UART-Smartwatch
powerCritical MOD !!

github.com/no-go/UART-Smartwatch

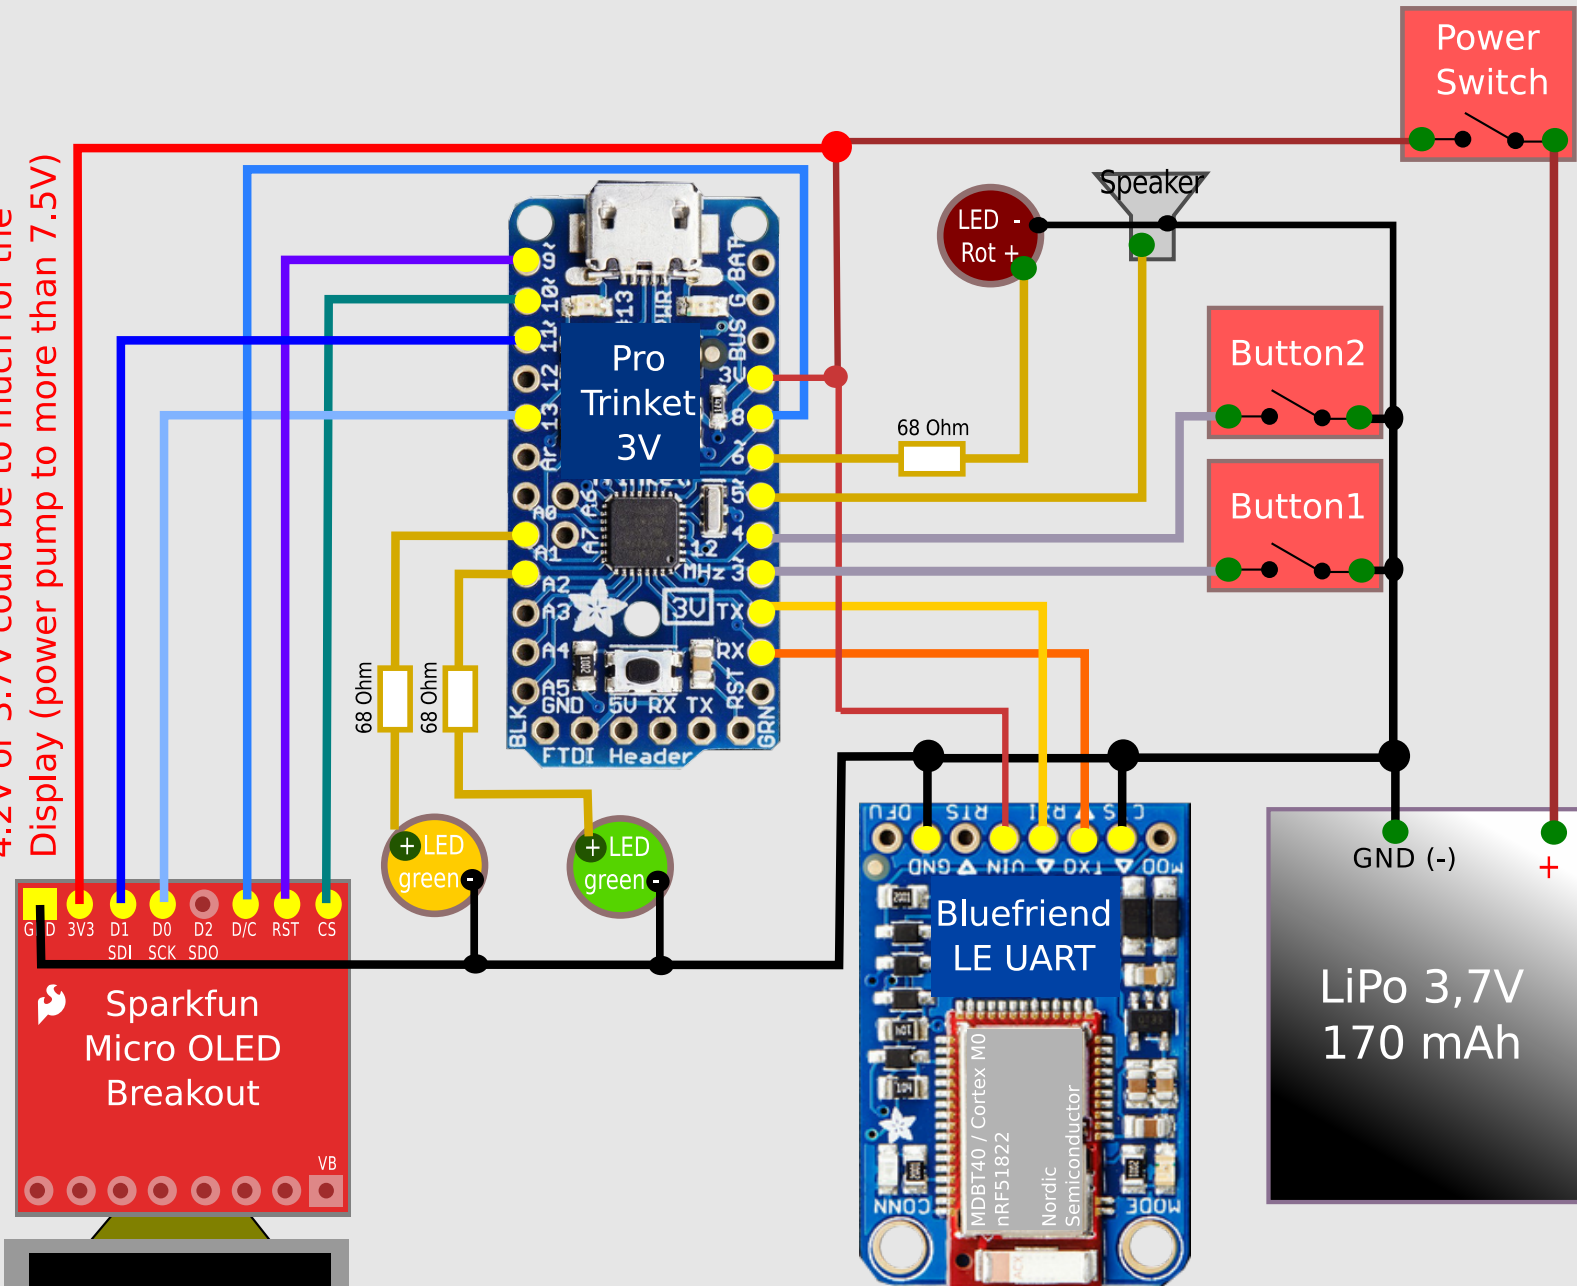
4.2V or 3.7V could be too much for the Display (power pump to more than 7.5V)
